RCA SERVICE LETTER 2025-06-03

Date: 03 June 2025
Subject: **VP-X and G3X EFIS Backup Battery configuration update**

Required Action: Change the VP-X backup battery circuit naming and Garmin G3X annunciation labels.

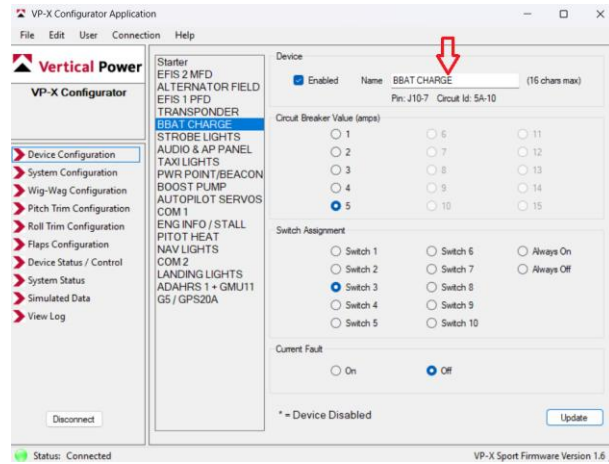
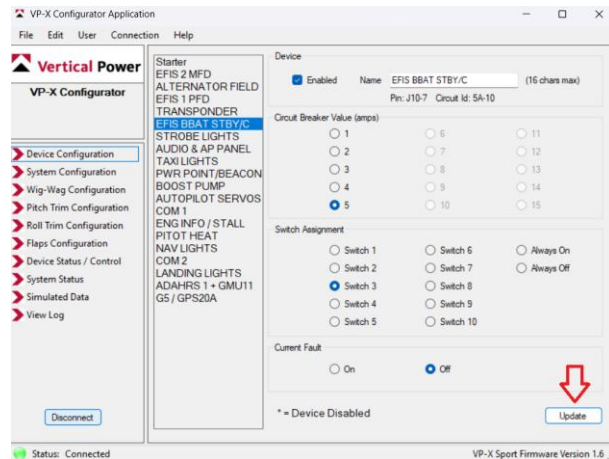
8. In the Device configuration menu, highlight the “BBAT CHARGE”, “BBAT STBY/CHARGE” OR “TCW3/6AH IBBS” circuit depending on how your aircraft was configured.

9. In the Name field on the top right of the screen, change the name to “EFIS BBAT STBY/C”

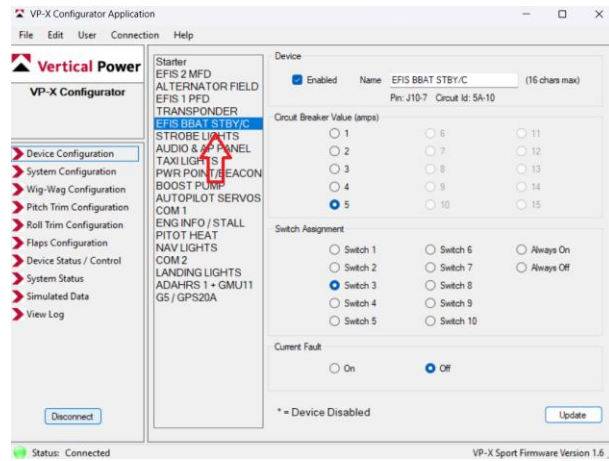
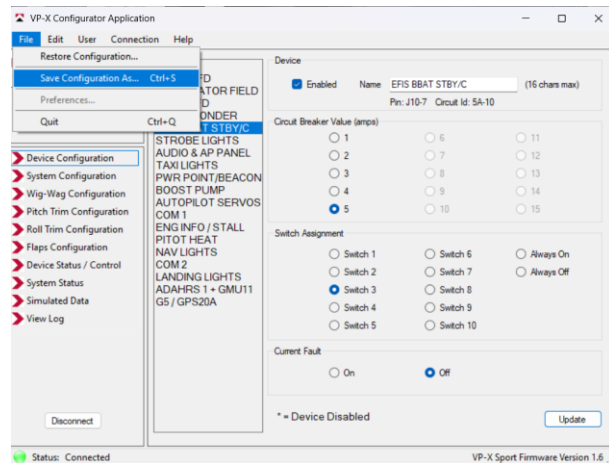
11. Name on the device menu should now say “EFIS BBAT STBY/C”

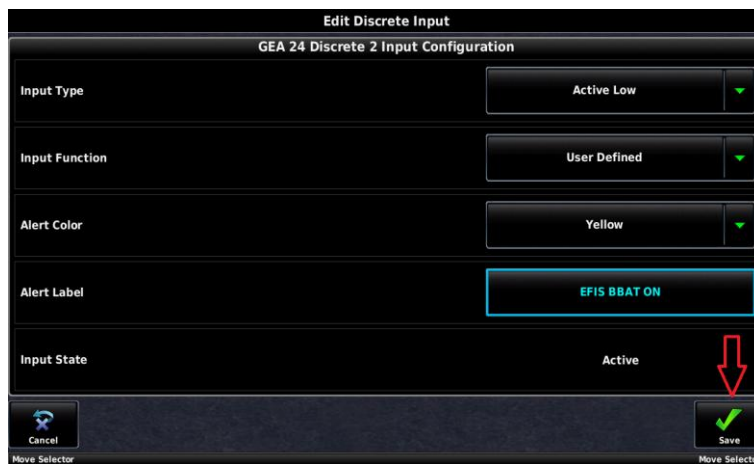
7. Change label text to read “EFIS BBAT ON” and press enter.
